# **STAFF COMMENTS**

## **ZONING BOARD OF APPEALS MEETING**

**Case # 4226:**                   **VARIANCE**  
167 Maryland Street  
Map: 127-C, Lot: 271

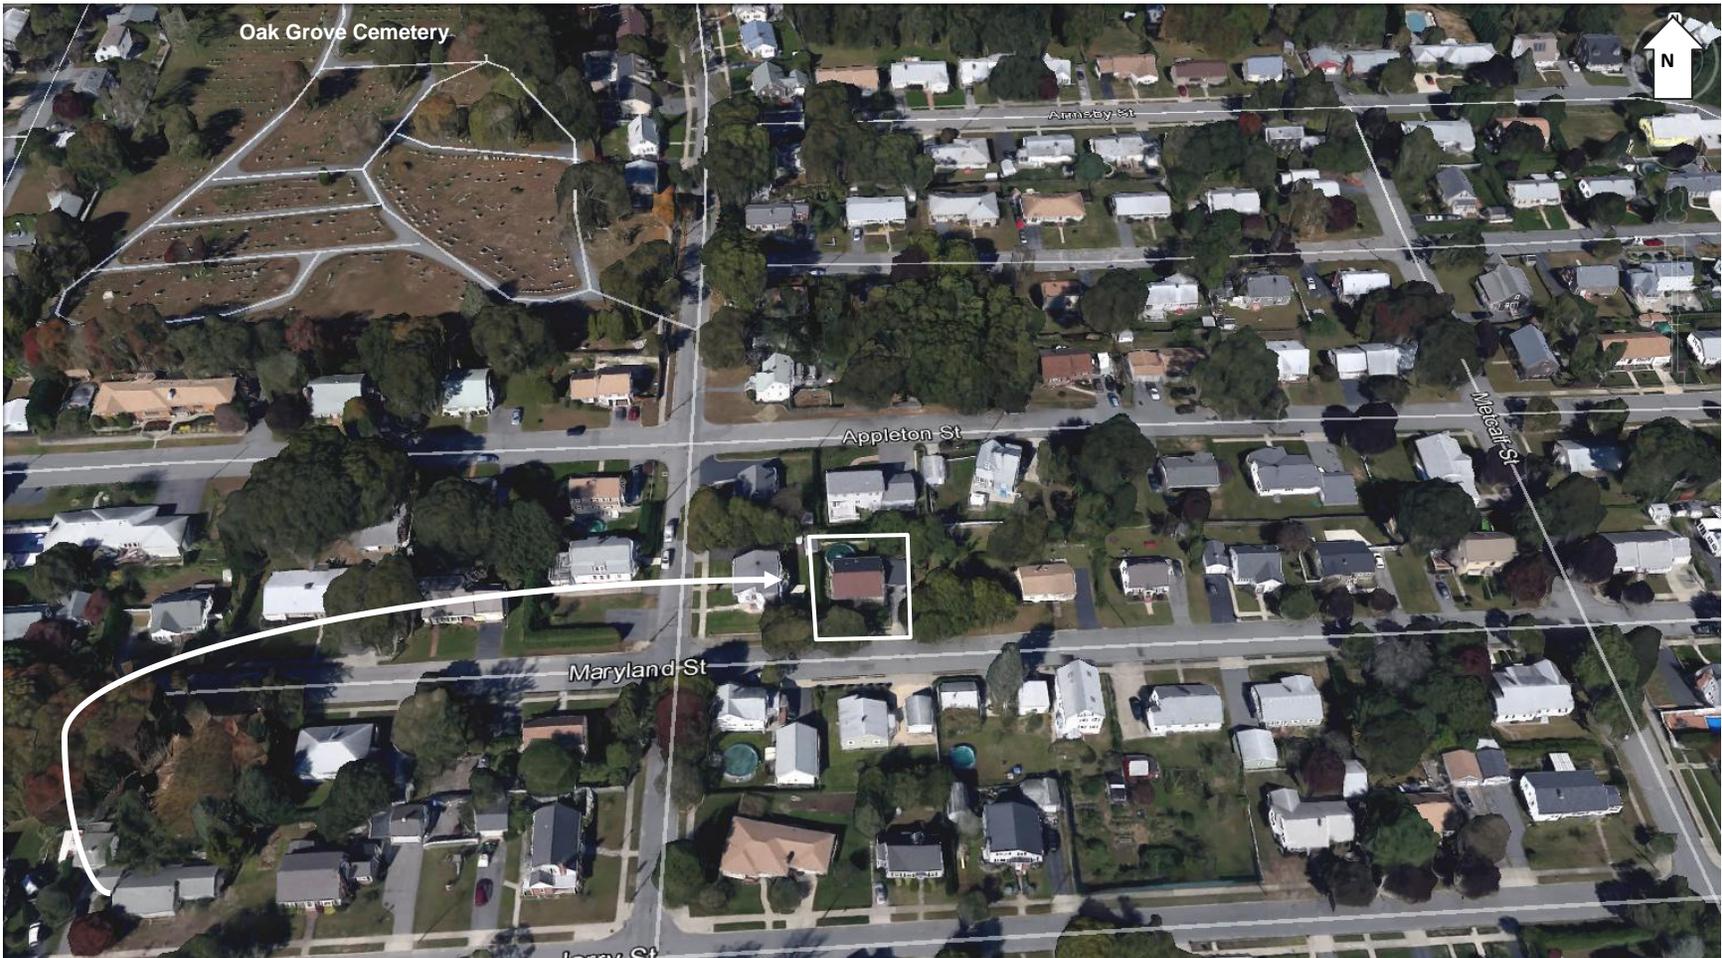
- The proposed bulkhead, which necessitates the setback relief from the zoning ordinance, will be 19' from the rear lot line. Despite this, the actual rear wall of the proposed addition will extend less than one foot further into the rear yard than the existing carport structure. Therefore, visually there will be minimal change to the rear yard setback.

- The board may wish to pay particular note to the elevation of the lot in combination with the location of the existing structure and driveway and how the grade changes between the subject property and abutting properties impact the request.

- The construction of the addition would result in the loss of one off-street parking space; as such the applicant seeks to widen his driveway to allow for side by side, rather than the existing tandem parking layout. Such a plan does result in the need to park in front of the residential dwelling. It is not unreasonable to need two car driveways in this location nor is that inconsistent with other neighborhood properties. Because it is unclear if the petitioner wishes to expand the curb cut and have an existing city street tree removed to accommodate a wider driveway entrance or if the driveway will flare out from the existing curb cut and widen to provide the two car space, staff recommends that the board seek such clarification from the petitioner.
